# Warragul and Drouin Precinct Structure Plans Review

2021

This section identifies and document amendments required to plans in both PSPs.

## Plan 6 – Biodiversity

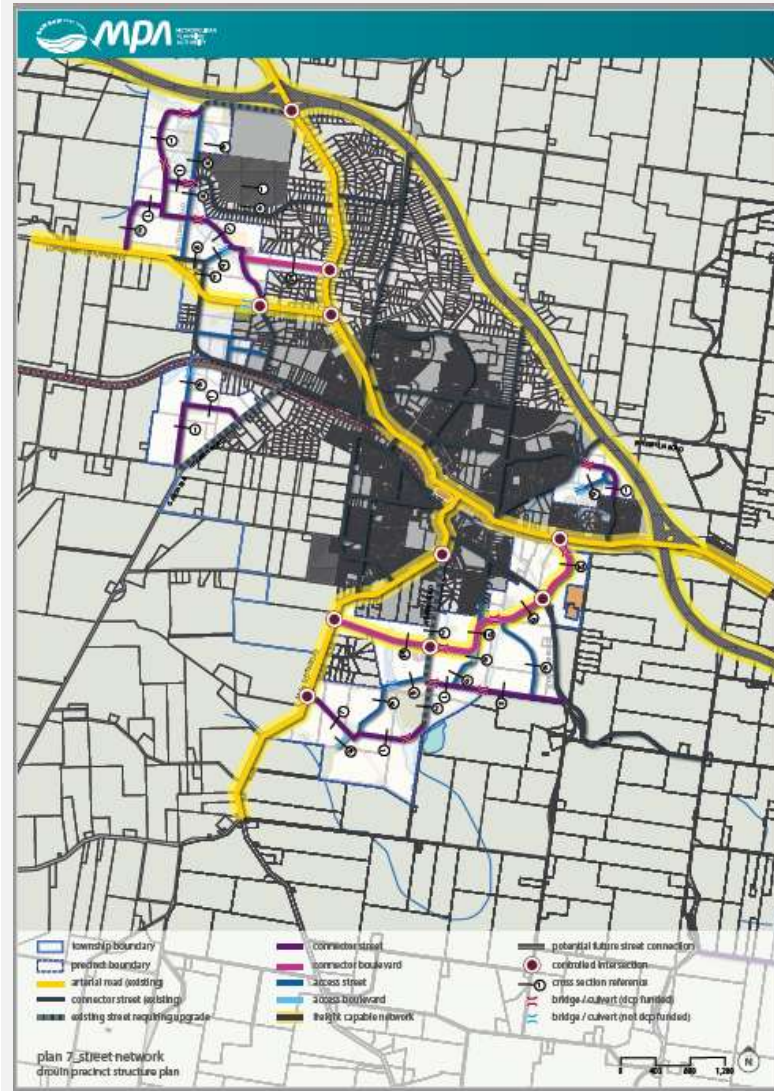
- The Plan refers to Environmental Significance Overlay Schedule 4 (ESO4 that provides protection for potential earthworm habitat). Amendment C108 that introduced Urban Growth Zone into Baw Baw Planning Scheme among other things removed ESO4 from UGZ areas. Reference to ESO4 in the plan is incorrect and should be removed. Similar correction is made to Requirement 29 in Drouin PSP.

- Include additional reference to the Vegetation Reserve (encumbered) VR-SE-05 to include *drainage reserve* to the area agreed by Melbourne Water as shown in Attachment 3. This will be consistent with Melbourne Water's Drainage Plan (corresponding changes are made to Plan 2 and Plan 9)

- All existing vegetation that is to be protected and retained should be shown on the plan.

- An appropriate planning control such as a Vegetation Protection Overlay is required to protect the identified vegetation. Due to lack of controls valuable vegetation has already been lost in some areas (e.g. significant vegetation has been removed along Gardner Holman Road, Drouin)
- Other plans in Drouin PSP and plans and concept designs in Drouin DCP should consider significant vegetation identified to be protected in this plan to avoid overlaps (e.g. Strzelecki trees along McGlone Road reserve shown on the plan will be at risk when road upgrades are undertaken as identified to the standards specified in Plan 7. The existing road reserve is narrow which will cause significant loss of these vegetation during road upgrades)

## Plan 7 – Street Networks

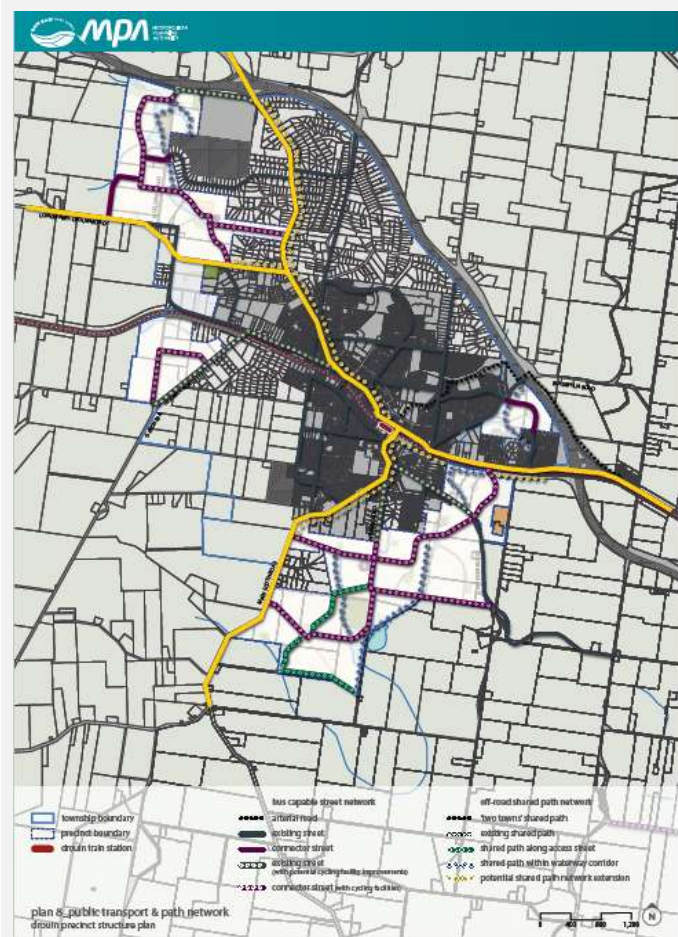
- Amend the plan to show '*Freight Capable Network*' as indicated in the legend to the plan
- King Parrot Boulevard should only be shown as '*Connector Boulevard*'
- Refer and label King Parrot Boulevard as '*Drouin Southern Boulevard*'
- Include cross section 2 reference for Gardner and Holman Road (currently no cross-section reference is given)
- On completion of the current Review of the Development Contributions Plans (Schedule 3) include any new projects on the plan (as needed)
- A '*further investigation required*' note to be included in brackets to '*potential future street (connection)*' shown on the legend to the plan (e.g. Fullarton Road). Details of the extension and cost should be explored. Until such time this cannot be required or imposed on planning permits, as such the above note is required.

## Attachment 1: Gippsland Water Changes to Plan 10 – Warragul PSP

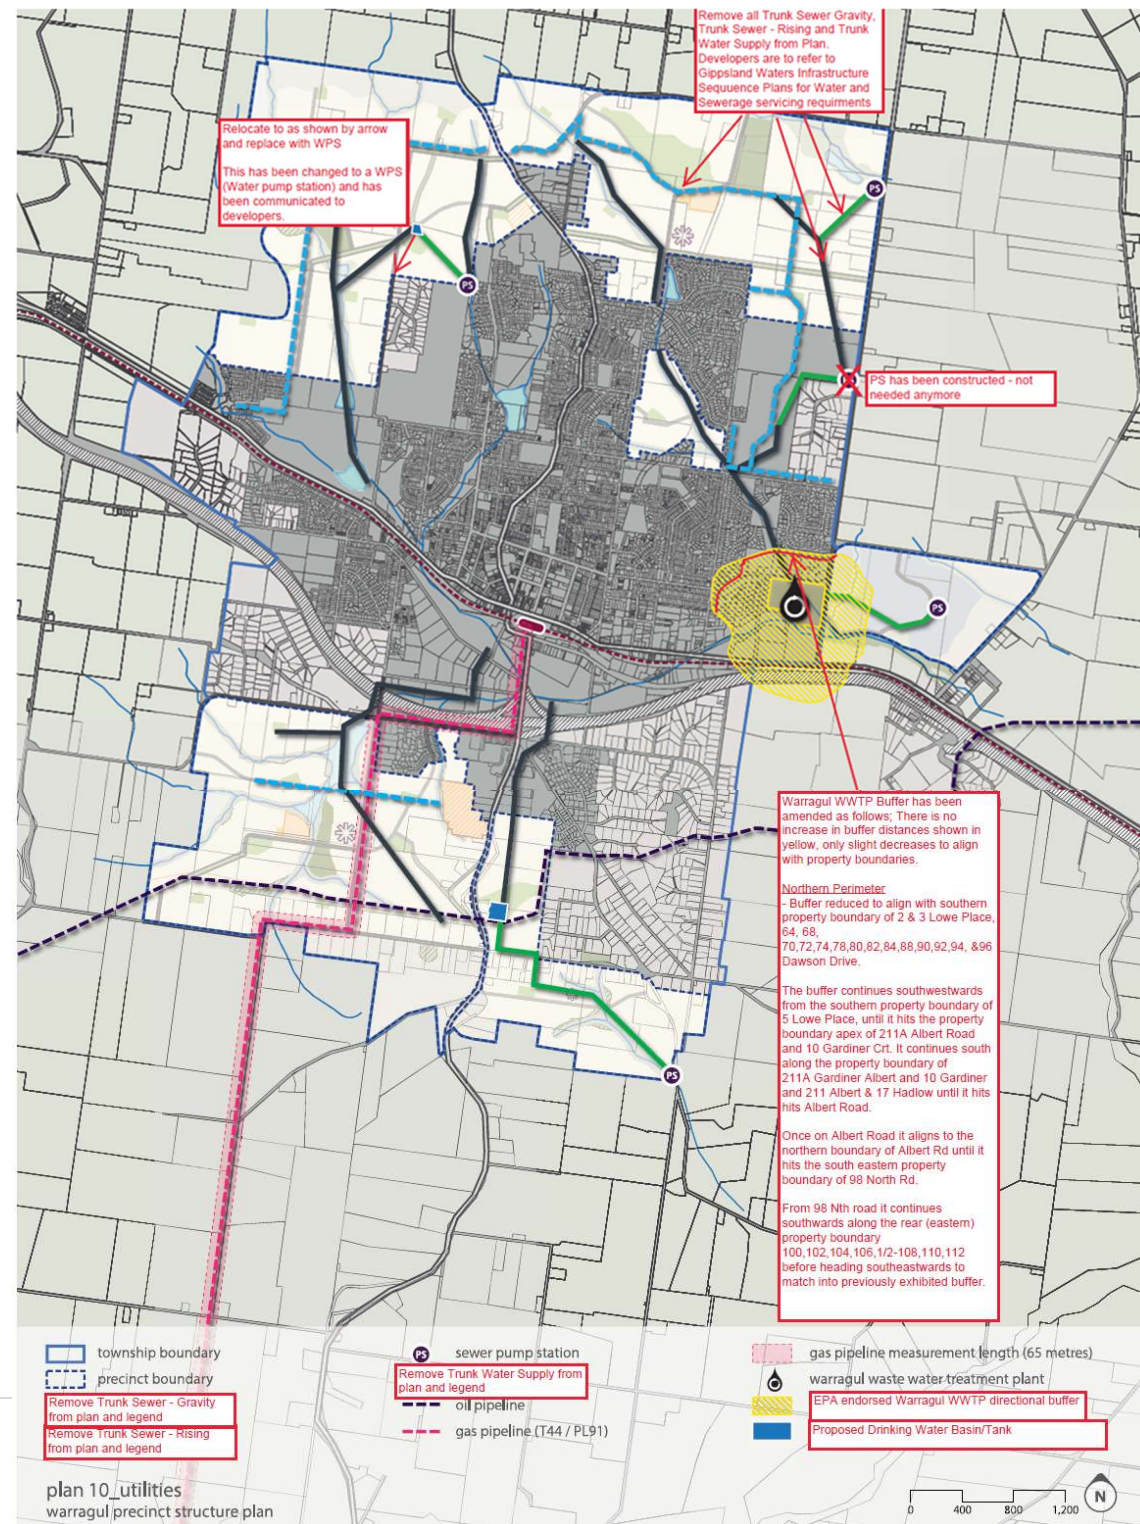
- Amend the plan to show the reduced buffer for the Warragul Wastewater Treatment Plant and the changes to the water and sewer pump stations, trunk sewer and trunk water locations as shown on the plan provided by Gippsland Water in Attachment 1.
- Amend the legend as below:
  - From the current legend “*treatment plant buffer (500 metres)*” to read *Warragul WWTP directional buffer in accordance with EPA Publication 1518: Recommended Separation Distances for Industrial Residual Air Emissions*;
  - From the current legend “*high-level water servicing site (Gippsland water)*” to read *Proposed Drinking Water Basin/Tank*

Attachment 2: Unmade roads shown as 'existing roads'  
in Plan 2 to be corrected – Drouin PSP

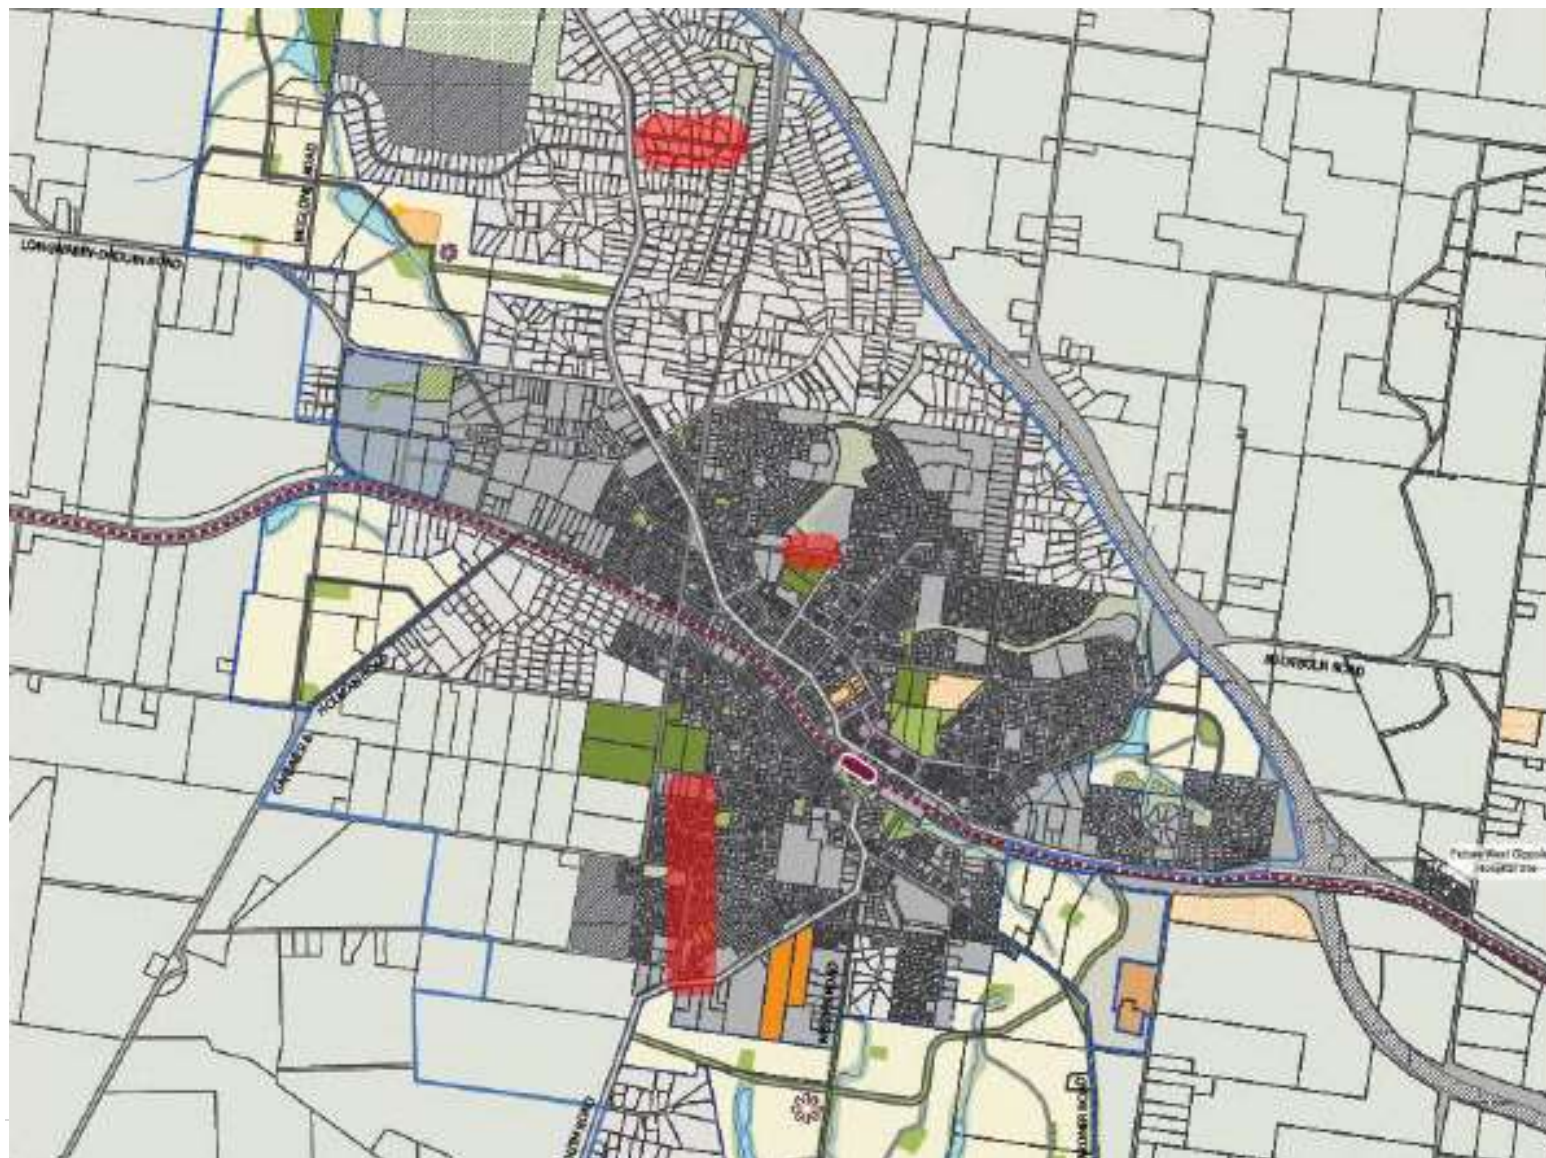
- Correct the reference to the following unmade roads on the plan which are currently shown as '*connector street existing*' (refer Attachment 2 for map showing the locations of the unmade roads)

### Attachment 3: Drainage reserve to be added in the Vegetation Reserve - Drouin PSP

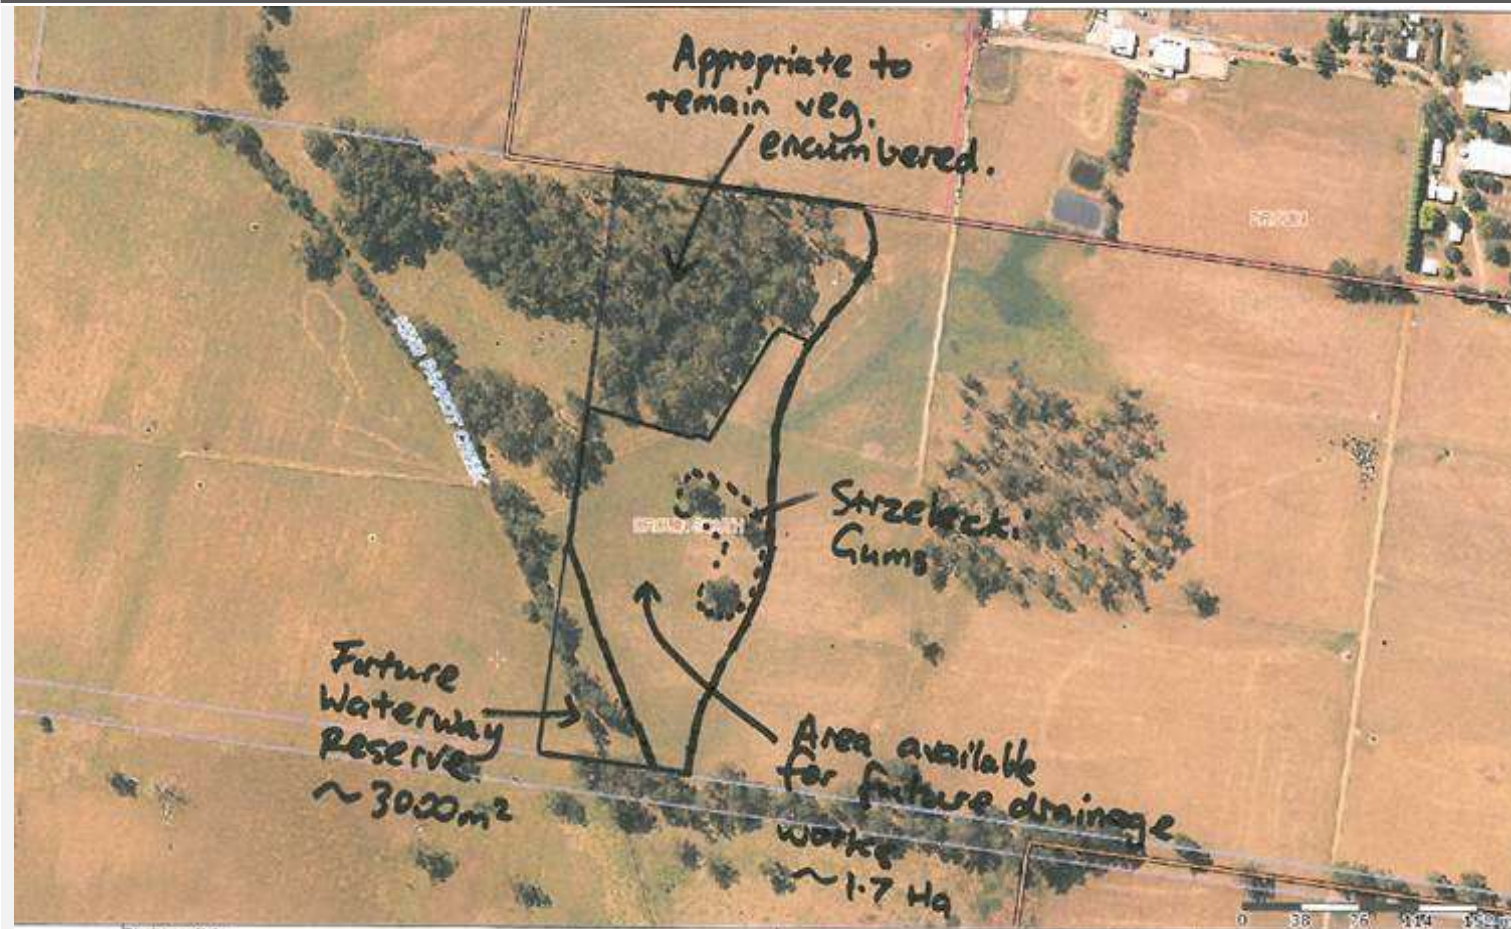
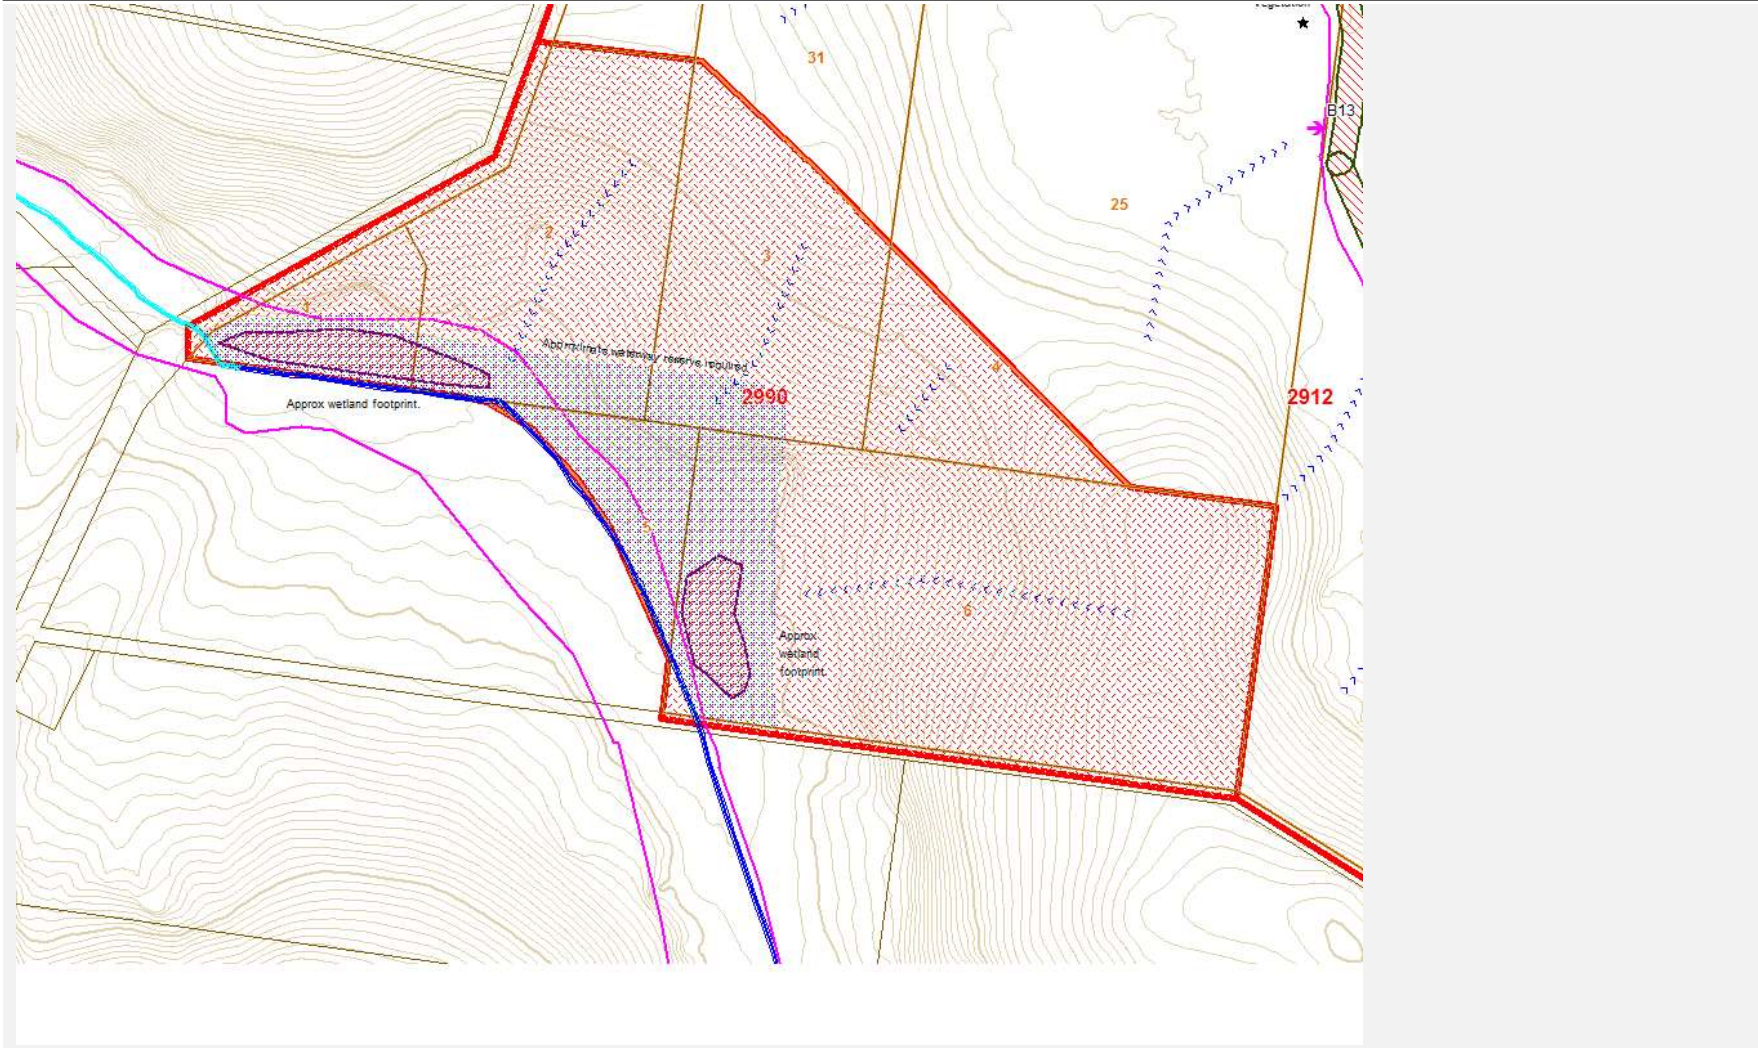
Indicative area to be changed from vegetation encumbrance to drainage encumbrance

Indicative area for drainage encumbrance

Extract from Melbourne Water Drainage Plan to make the above change
